3090 Zone North Interim Tank

CITY OF LAS VEGAS INTER-OFFICE MEMORANDUM		DATE: April 27, 2017
TO: Land Development Services Department of Building & Safety		FROM: Albert Sung, P.E. Flood Control Project Engineer Department of Public Works
SUBJECT: Drainage Study for: 3090 Zone North Interim Tank		COPIES TO: Slater Hanifan Group
Cross Streets:	NWC of Centennial Parkway and Puli Road	Ninety-Five Management, LLC
File Number:	F:\Depot\DSMemos\DS4854B.doc	Bart Anderson, P.E., DevCo
Parcel Number:	126-23-000-001	
Zoning Action:	SDR-xxxxx	
FEMA Flood Zone	YES NO X	
Proposed Storm Drain	YES NO X

Subject: Response to Comments for Technical Drainage Study for 3090 Zone North Interim Tank (DS-4854)

Subject: Response to CLV Comments to the Technical Drainage Study for 3090 Zone North Interim Tank (DS-4854)

EXHIBIT G

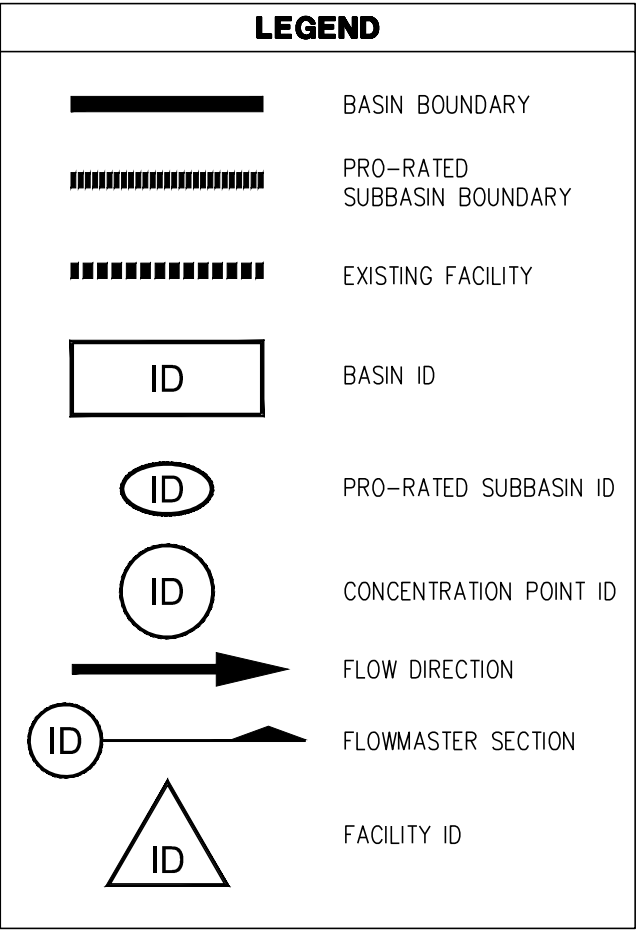
1. **Comment:** *The proposed water reservoir outfall/discharge pipe is not connected to the permanent storm drain facility. Please connect the outfall pipe to the existing storm drain facility in Centennial Parkway at Puli Road alignment.*

Response: A discharge channel has been graded adjacent to the Centennial Parkway access road, this channel will allow conveyance of the reservoir discharge (approximately 20 cfs) and 100-year storm event runoff into the storm drain facility along Puli Road and Centennial Parkway intersection. The channel has extended the watershed analysis in the proposed and ultimate conditions. Relevant hydrologic calculations for the extended watershed has been provided in Appendix B.

The section is representative of the minimum and maximum slope along the channel; the utilized flowrate for the channel is concentration point CP3 in the ultimate condition and the tank discharge which generates the worst case flowrate. A summary of the section analysis has been provided in the table above. Hydraulic calculations for the channel has been provided in Appendix C and refer to revised Exhibit G in Appendix B for location of the hydraulic section.

DRAWING NUMBER CD 5
SHEET 19 OF 28

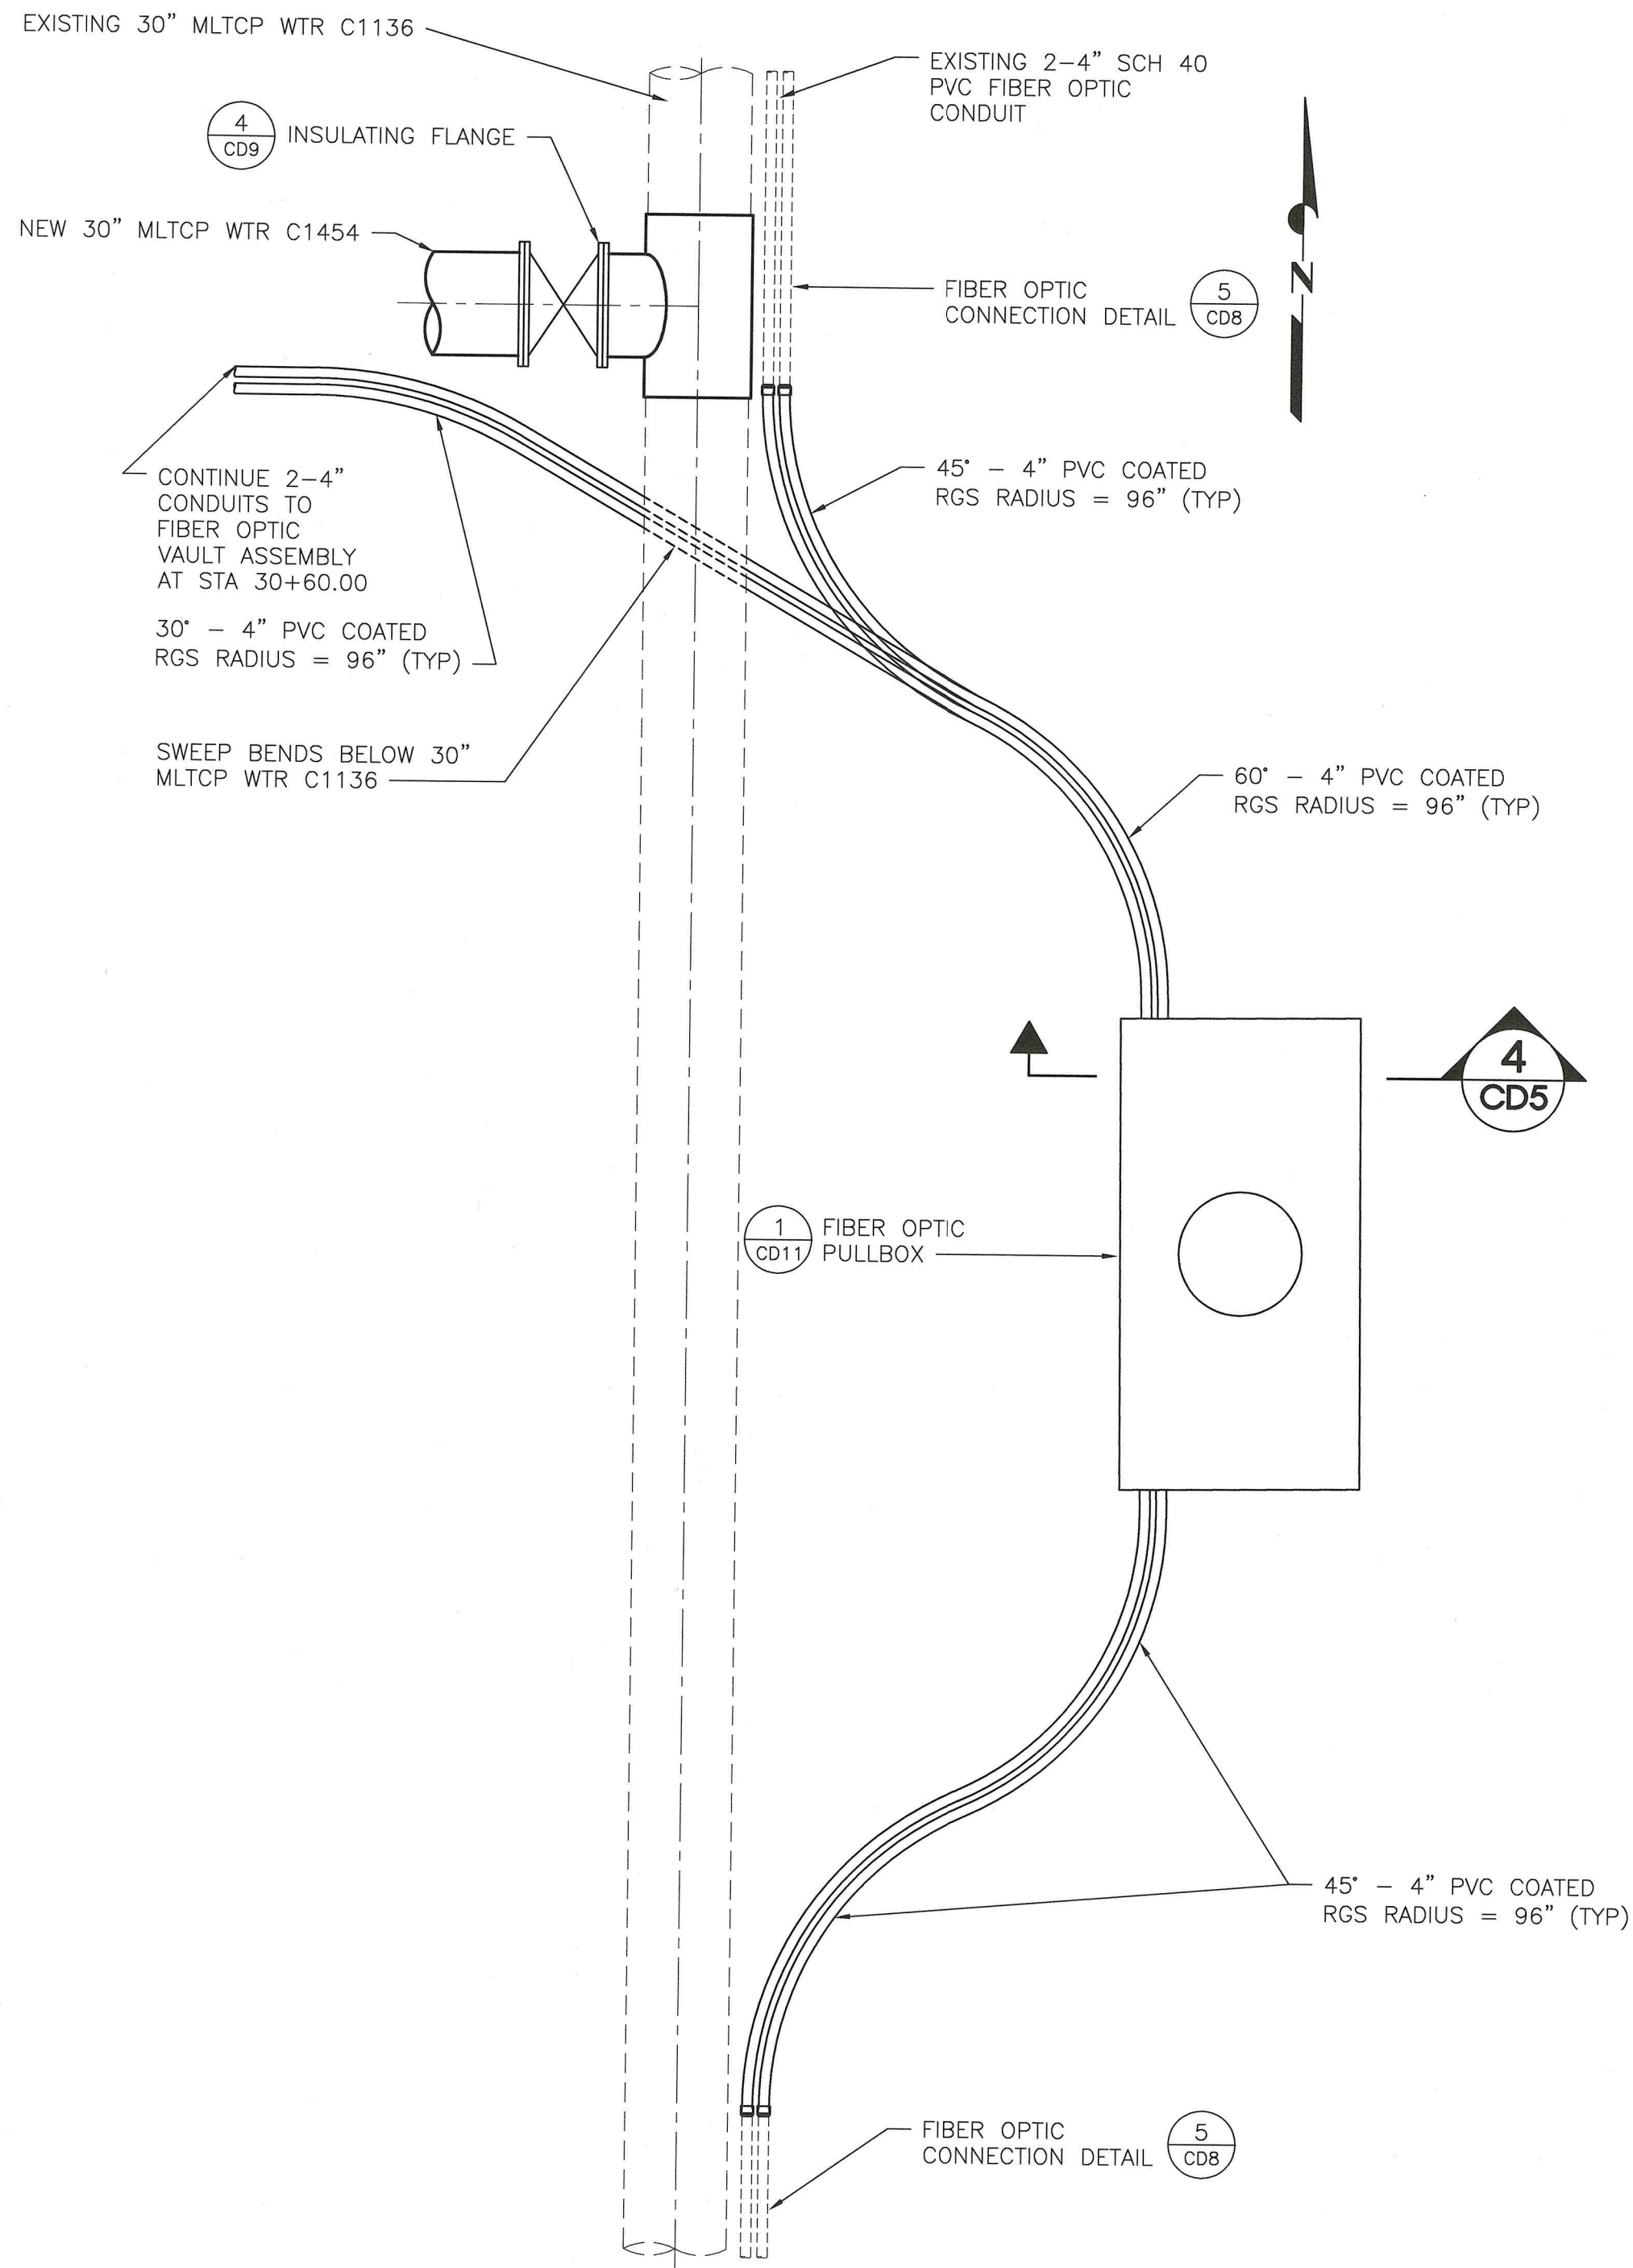
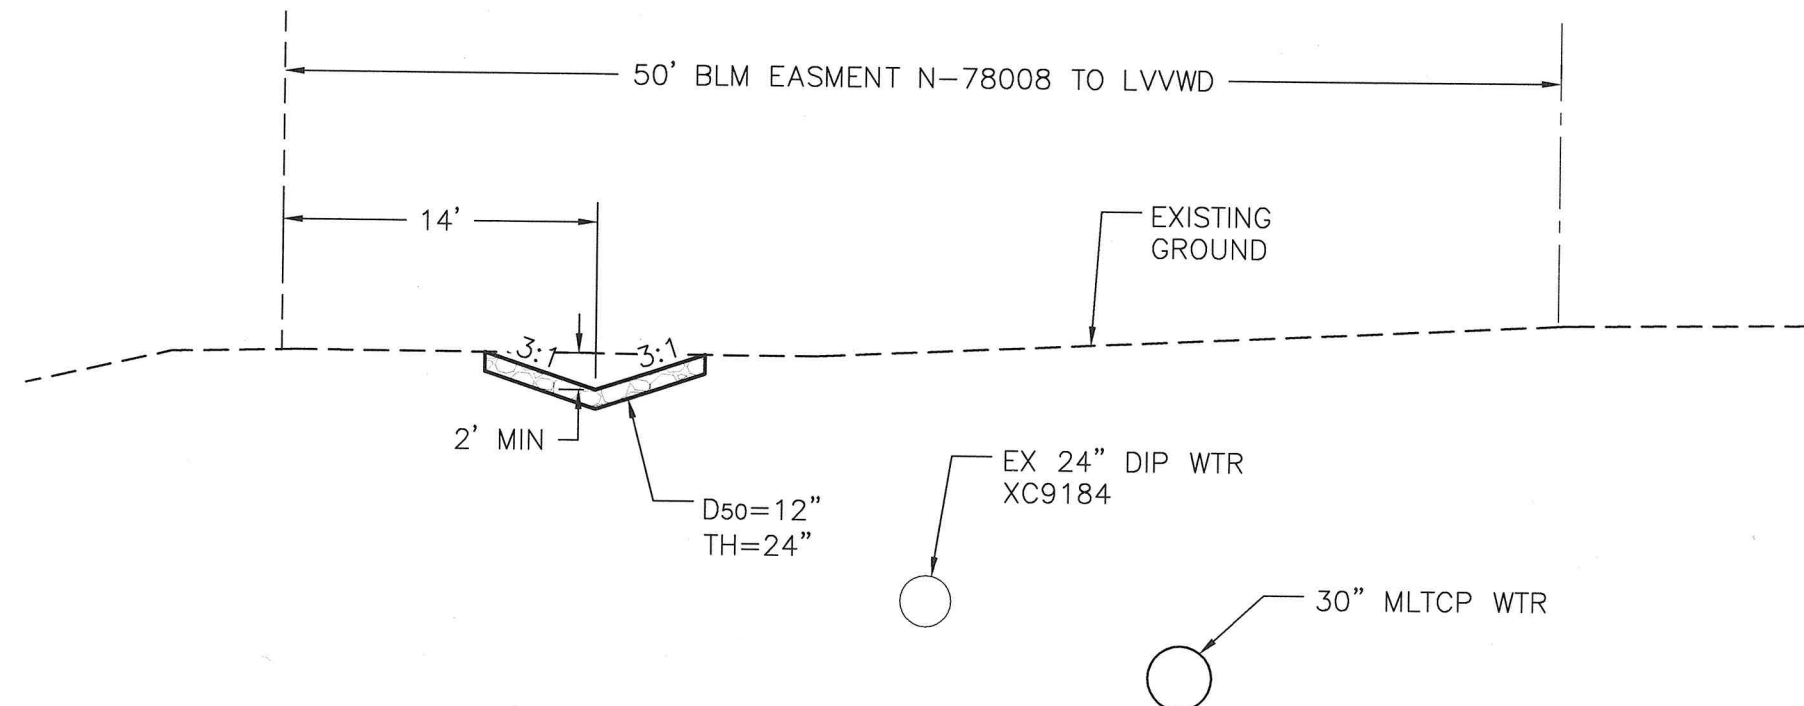
- Provide riprap sizing calculation for the access roadside channel in *Centennial Parkway* to Flood Control Section prior to the final approval of the improvement plans.
- In *Section Detail A/CD5*, provide a layer of geo-filter fabric beneath the proposed riprap over compacted base for erosion protection.
